SALUDA HYDROELECTRIC PROJECT
(FERC NO. 516)

**DOWNSTREAM RECREATION FLOW ASSESSMENT
STUDY PLAN**

FINAL

RESPONSE TO COMMENTS SUBMITTED TO DRAFT STUDY PLAN

Figure 2: Study Area for Downstream Flow Assessment and Approximate Locations for Level Loggers
 (Source: South Carolina Department of Natural Resources, as modified by Kleinschmidt)

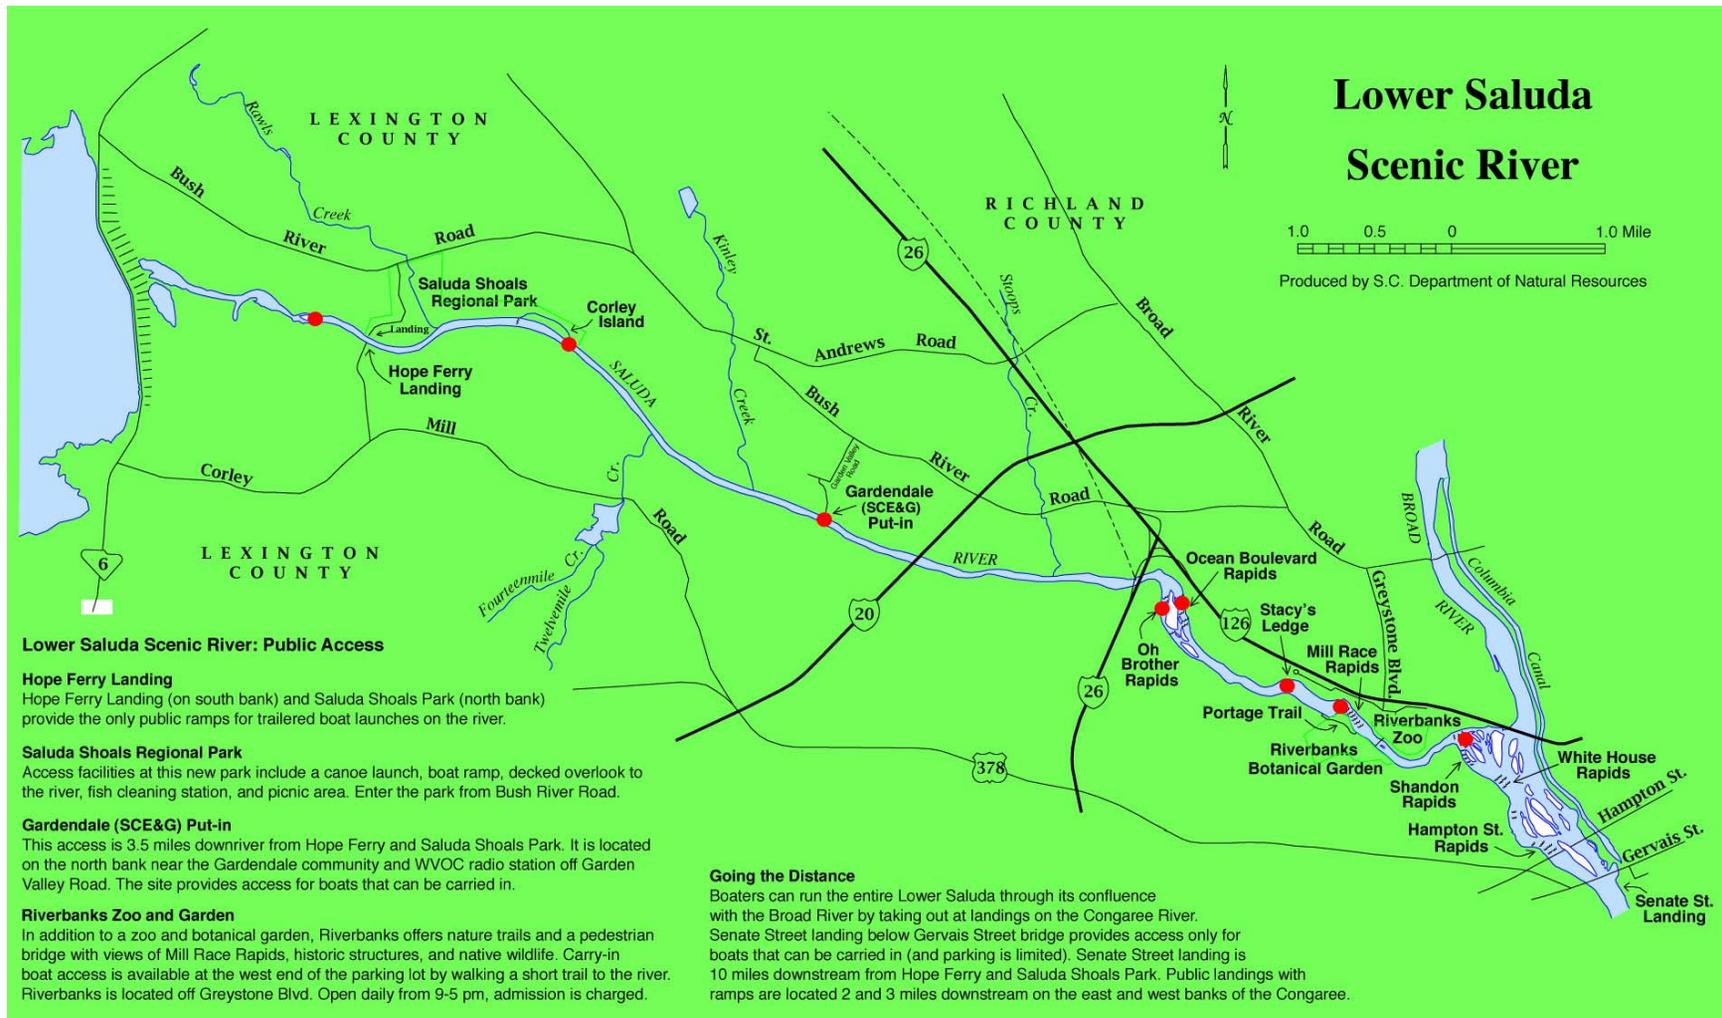
Tony Bebber	Red dots are insufficient areas to consider. These appear to be major kayaking areas. You must consider other recreational activities – wade fishing, bank fishing, swimming, tubing, rock use, sunbathing, picnicking, walking, bicycling, etc.	Red dots correlate with the HEC Res-Sim model cross sections that will be used for assessment of recreational flows and provide a range of hydrological conditions (pools, riffle, shoals). Red dots also correlate with or are within proximity of recreation access sites. Recreational activities are likely concentrated in areas in proximity of these access sites (for example, rock use, sunbathing, etc. occurs frequently at Mill Race, which is also considered a kayaking area).
